SUBJECT: DENIAL, WELLFIELD UNIT 1 GROUND-WATER RESTORATION  
APPROVAL, CROW BUTTE RESOURCES *IN SITU* LEACH FACILITY,  
LICENSE NO. SUA-1534 (TAC No. L52376)

## Technical Evaluation Report

**FACILITY:** Crow Butte Resources *In Situ* Leach Uranium Project, Chadron, Nebraska

FIGURE 1. Unit 1 Radium-226 Measurements

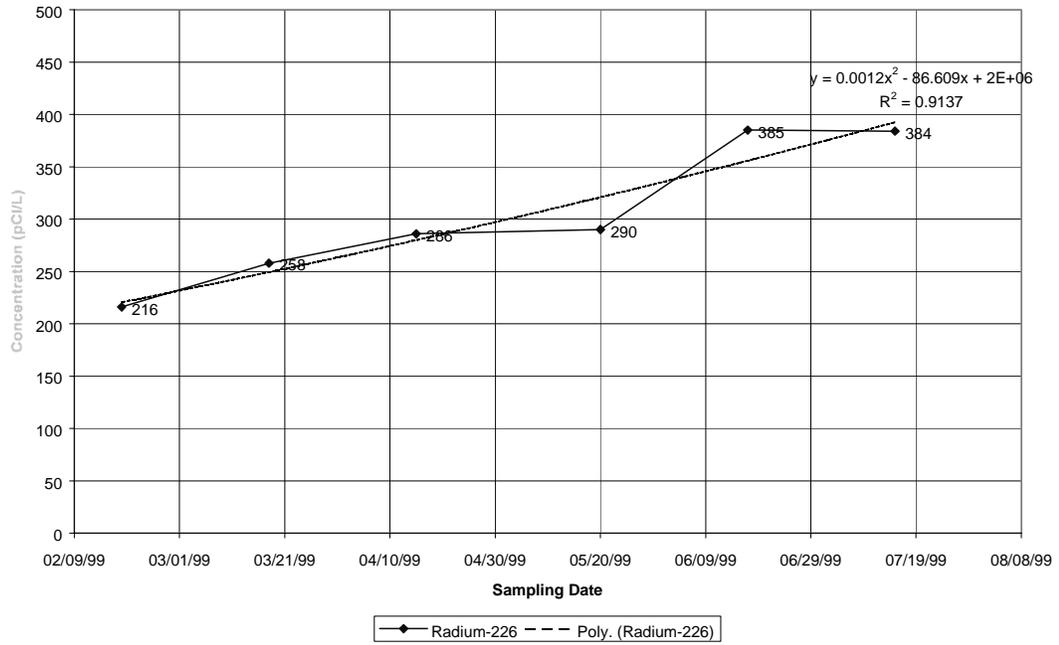
1. **Finding:** Staff’s analysis indicates that concentrations of ammonium, iron, radium-226, selenium, total dissolved solids, and uranium show strongly increasing concentration trends over the stability monitoring period. These trends indicate a reasonable likelihood that license limits would be exceeded in the near future. Other constituents appear to have reached stability, or exhibit such a weakly increasing trend that stability is not a concern. Figures 1, and 2, provide examples of strongly increasing concentration trends in the monitored data during the stability monitoring period. These increasing trends represent a particular concern when a constituent has been restored to the secondary restoration goal, as these two examples were. The secondary restoration standards are greater than the pre-operational baseline concentrations, but are considered protective of the adjacent aquifer beyond the limits of the U.S. EPA designated aquifer exemption boundary. Increasing trends that indicate a potential future exceedance of baseline limits do not represent an immediate concern, since the secondary limits are higher than the baseline limits and are considered protective. Figures 3, and 4, illustrate two constituents that appear to have stabilized during the stability monitoring period. Although Figure 3, shows an increasing trend, this trend is not significant. Figure 4 shows a strongly increasing trend in the early measurements, but the trend dissipated by the time the later data were collected.

1. The licensee's request for Unit 1 wellfield restoration approval should be denied.
2. Decommissioning of Unit 1 should not proceed at this time.
3. Stabilization ground-water monitoring in Unit 1 should be restarted immediately at the monitoring locations described in the January 10, 2000, Restoration Report. The ground-water should be sampled and analyzed for the constituents listed in License Condition 10.3B, SUA-1534, on a schedule of at least 14 days apart. The wellfield restoration shall be considered stable if four consecutive sampling episodes show no strongly increasing concentration trends for all monitored constituents, on a wellfield average, as described in Section 6.1.3, "Standard Review Plan for *In Situ* Leach Uranium Extraction License Applications," NUREG-1569.
